# BULLETIN

## RECALL

### 2006~2008 and Certain 2009 FJR1300A/AE FACTORY MODIFICATION CAMPAIGN – Main Switch

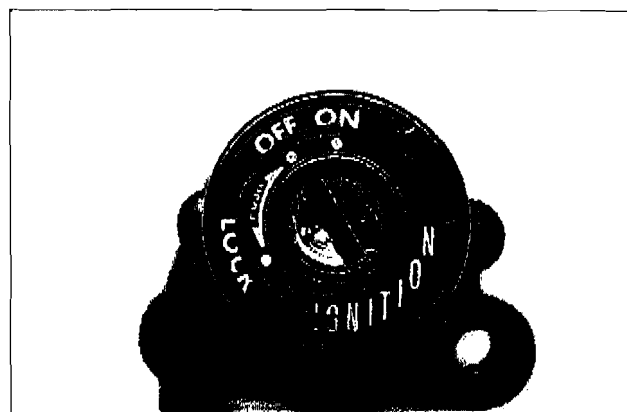
21. Remove the "red circled" protective cover from the top of the main switch. The new main switch is now ready to be installed on the upper triple clamp.

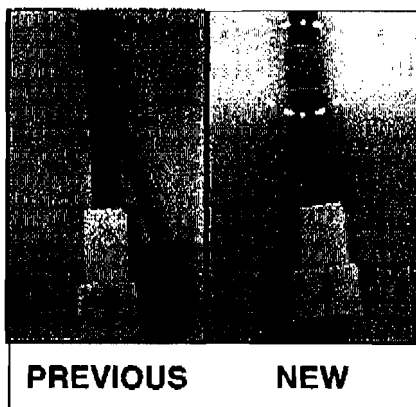
A new main switch can be identified by the yellow band on the harness near the connectors.
